ADMINISTRATIVE APPROVAL (PD) ADD2024-00060

ADMINISTRATIVE APPROVAL
LEE COUNTY, FLORIDA

Exhibit B: Master Concept Plan entitled "Siesta V" received 08/13/2024
Site plan approved per ADD2023-00123

SIESTA V

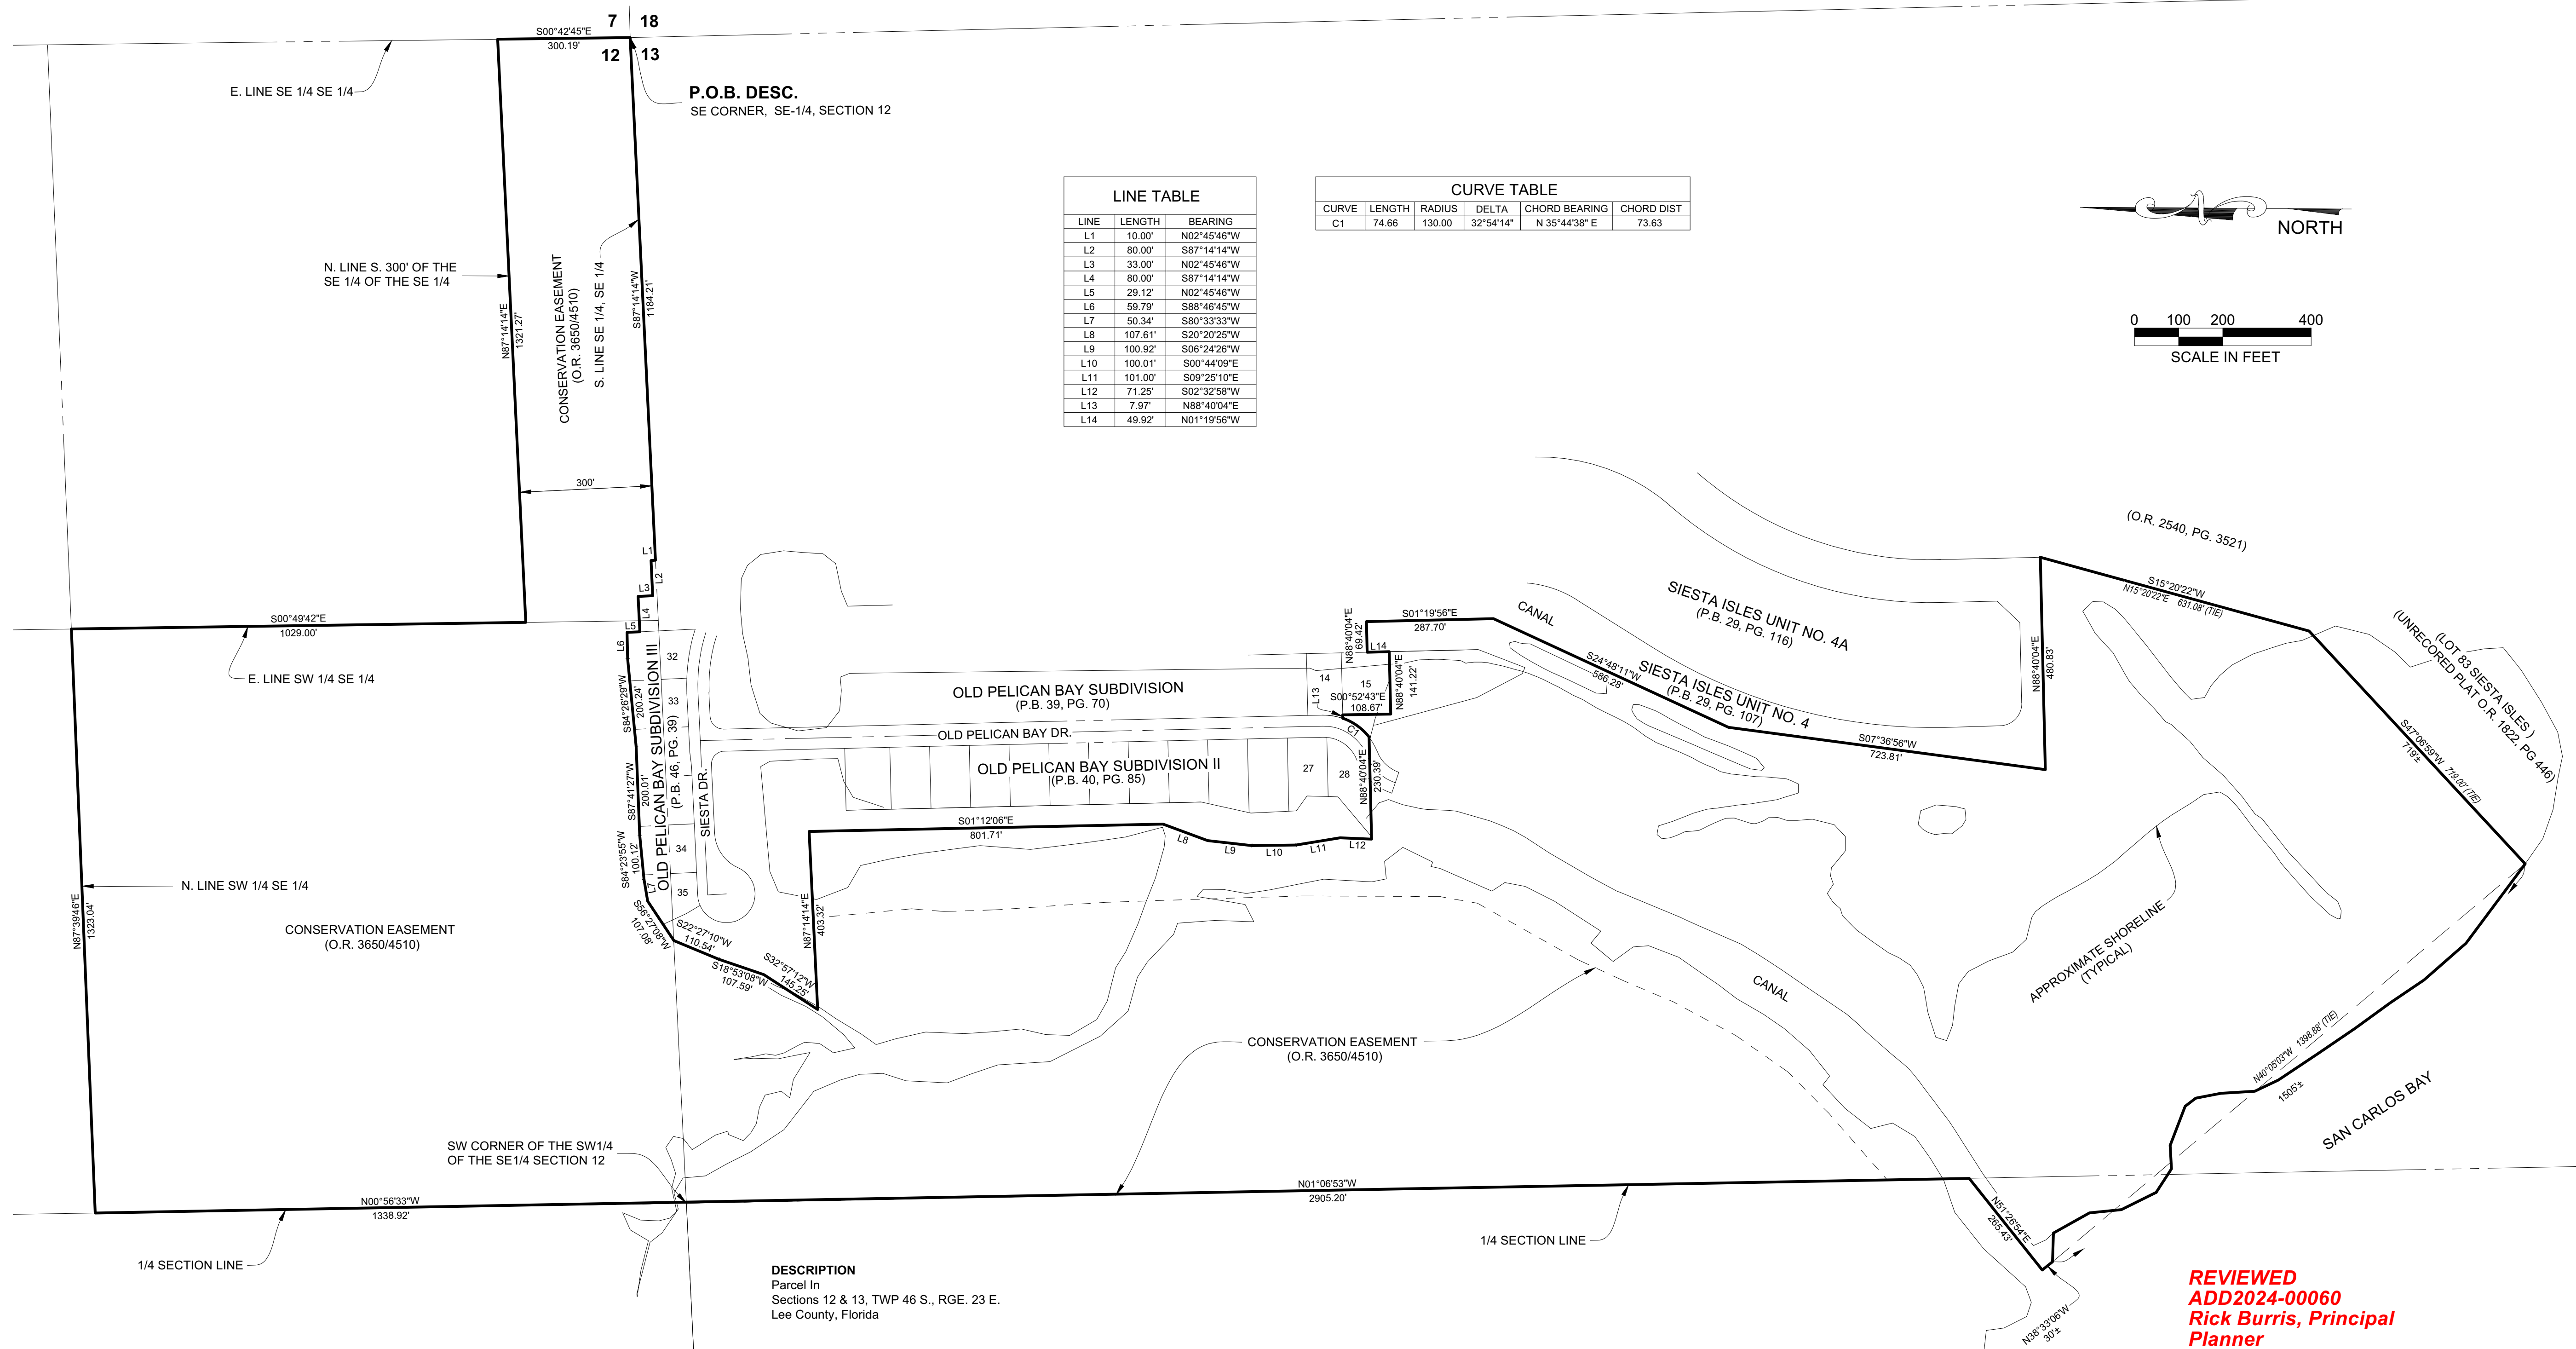
1. Elimination of the 11-slip multi-family docking facility in Pelican Bay.
2. Elimination of four lots and two shared docks along the shore of Pelican Bay.

3. A reduction in project density from 41 single-family dwelling units to 36 single-family dwelling units.
4. Elimination of the roadway and utility infrastructure serving the eliminated lots, two docks, and 11 slip docking facility formerly known as "Northern Harbor Lane."

5. Addition of 4.06 acres of conservation land, including the formerly proposed upland lots and the privately-owned submerged lands where the 11-slip docking facility and the single-family docks would have been located.

6. Planting of +/-250 lineal feet of mangroves along the east side of the road in front of single-family Lots 15-18 in accordance with the FDEP requirements for planting and monitoring in the Environmental Resource Permit.

7. Removal of Condition 4 of Resolution Z-02-049, which required an elevated roadway/bridge of 100+/- lineal feet and the relocation of 3 of the 4 lots along Pelican Bay to the bridge location.

- 1. The development of this project must be consistent with the one-page Master Concept Plan (MCP) entitled "Siesta V", dated 08/13/2024 and attached hereto as Exhibit "B."**
- 2. This administrative amendment supersedes Resolution Z-02-049 (Exhibit "C") and ADD2023-00123 (Exhibit "G") and codifies all conditions and deviations into the conditions and deviations attached hereto as Exhibit "C."**

4. The development order plans must depict +250 lineal feet of mangroves abutting Lots 15-18 pursuant to the Department of Environmental Protection requirements for planting and monitoring in the Environmental Protection Resource Permit.

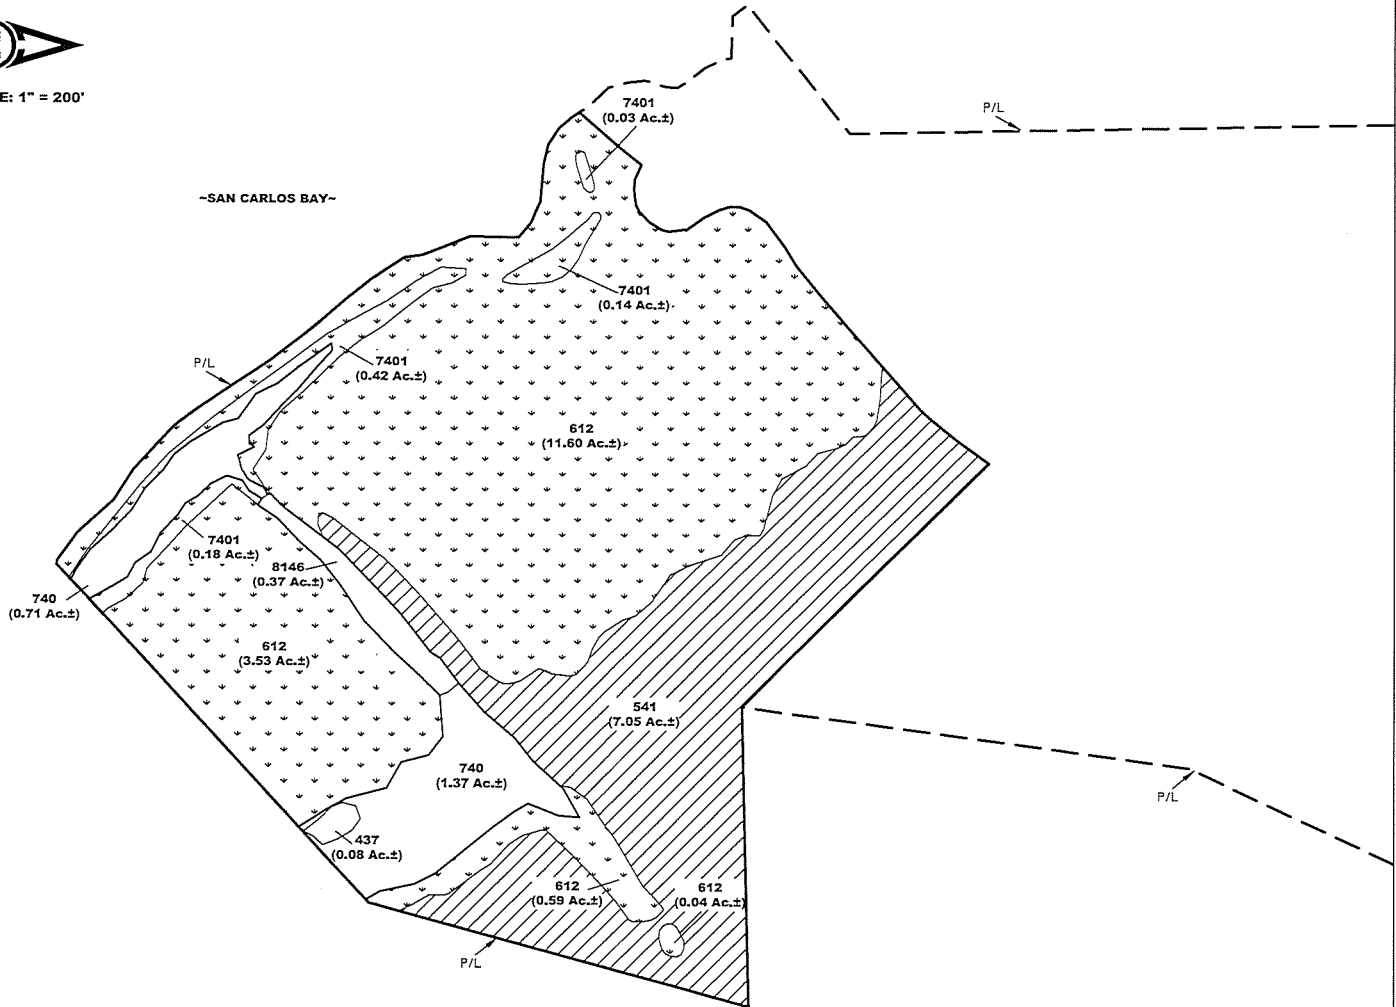
WHEREAS, the applicant submitted a Tidal Flushing Analysis demonstrating that the tidal flushing area has ground elevations that are measured at mean high water indicating that there are no areas where the water connects to Pelican Bay or San Carlos Bay at high tide (Exhibit "D"); and

WHEREAS, the land between either bay has a ridge that is approximately three feet high and has *Sabal palmetto* (Cabbage Palm), *Pithecellobium unguis-cati* (cat's claw), and *Coccoloba uvifera* (sea grape), which are indicator species of an upland habitat; and

Based on the vegetation data, topography, and tidal flows, significant tidal flushing does not occur directly from San Carlos Bay to the mangroves in the southern portion of the Project site. As documented by the vegetation associations and topographic data, there is a ridge along the shoreline parallel to San Carlos Bay that blocks average daily tides from flowing into the mangroves in this location. Significant tidal flushing occurs through Estero Pass into the Siesta Isles canal system and then to the mangroves within the study area.

CROSS SECTION A-A

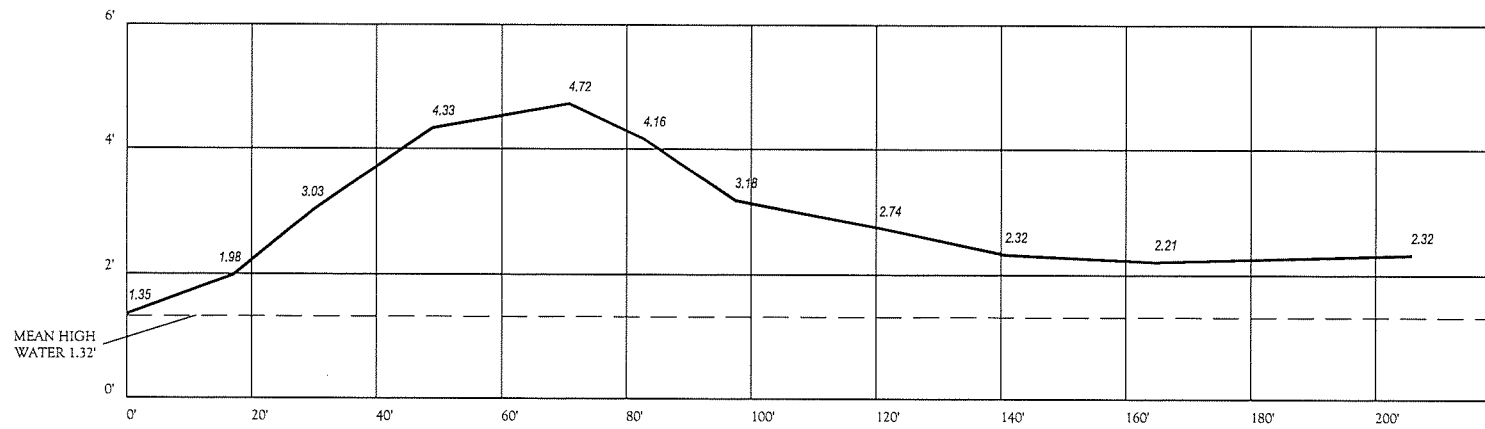
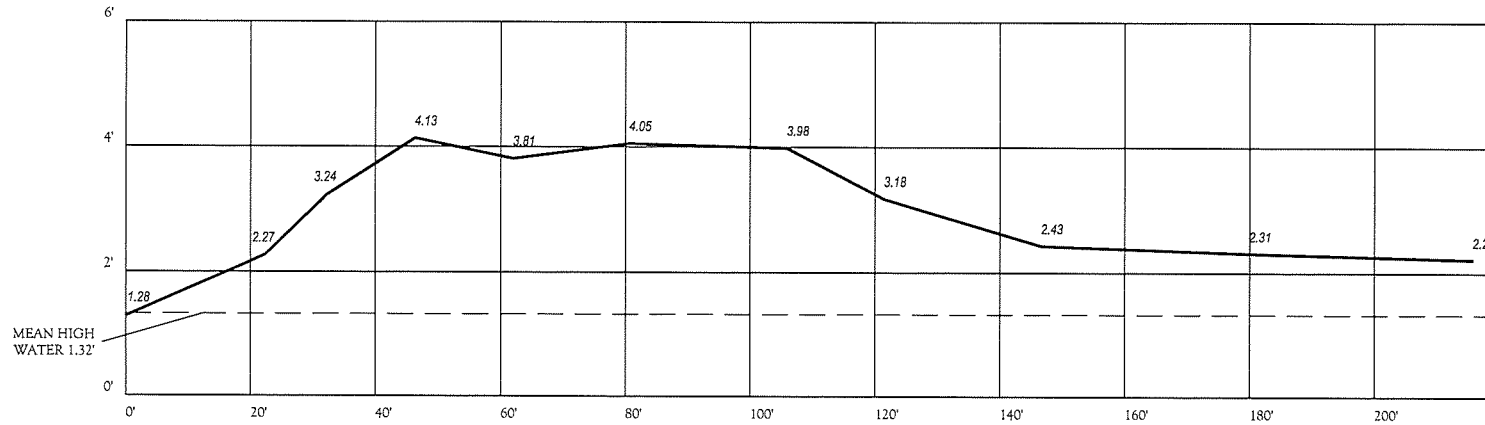
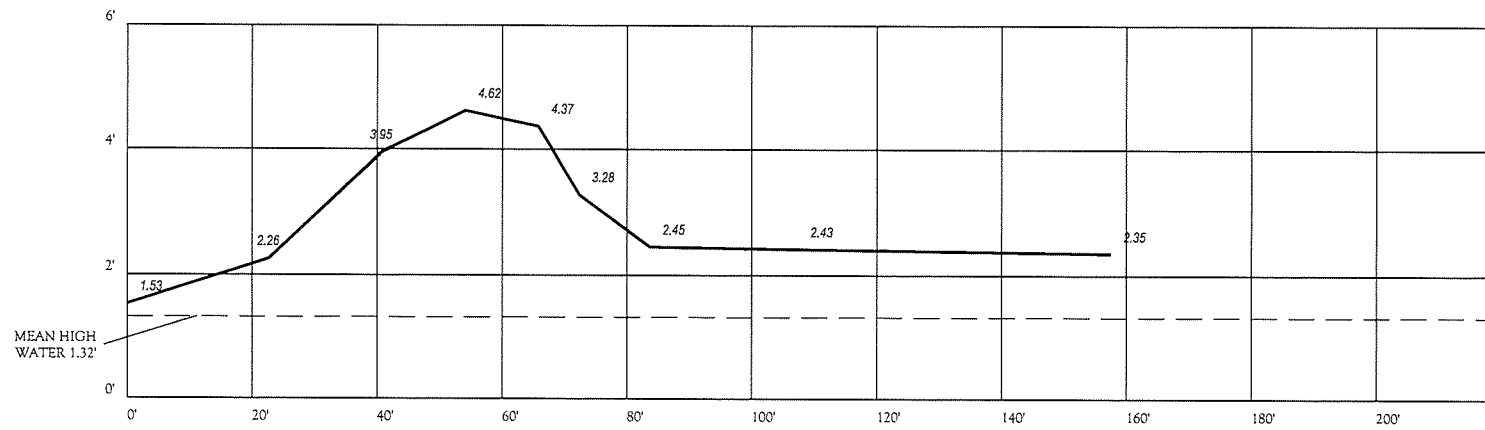
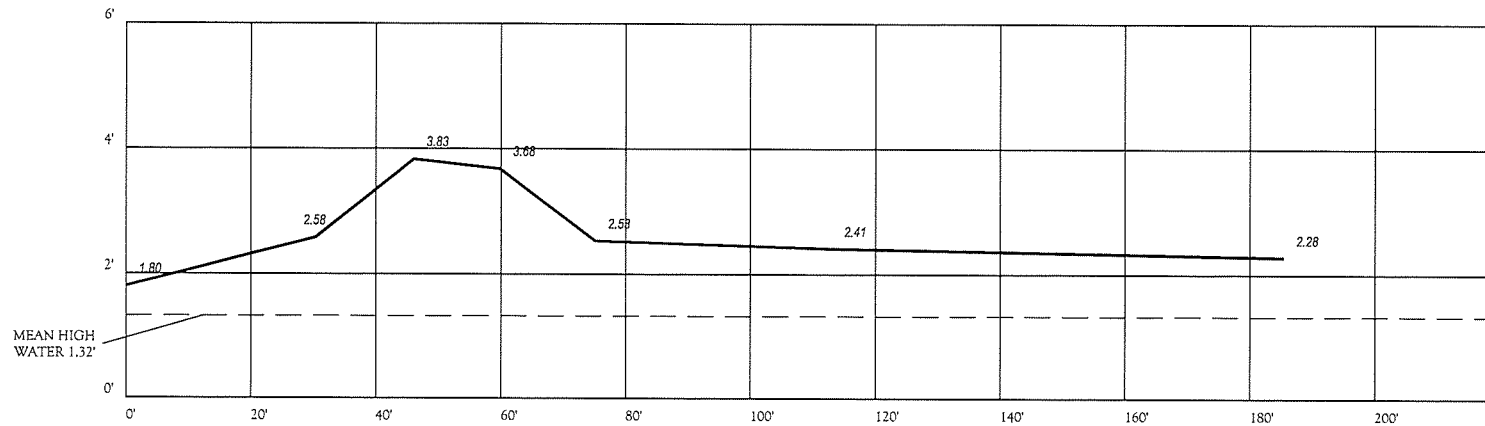
Barraco and Associates, Inc. surveyed ground elevations within the study area in August 2023 and February and June 2024. The surveyed elevations in National Geodetic Vertical Datum of 1929 (NGVD) are shown on Sheet 2 (attached). Cross sections of the ground elevations are also provided on Sheet 2 (attached). The cross sections include the MHW line, which in this location is 1.32 feet NGVD. Also, for reference, the Mean Low Water (MLW) elevation for this location is -0.48 feet NGVD.

In order to support significant tidal flows, areas of open water with bottom elevations below MLW are required. Since the ground elevations within the study area are above MLW, significant tidal flushing is not occurring along this portion of the Project site. Tidal flows within this general area occur through Estero Pass to the southeast and then into the canal system within Siesta Isles. See Sheet 4 (attached). At the nearest point, the Siesta Isles canal system has a cross-sectional area of approximately 600 square feet below MLW, which provides significant tidal flows.
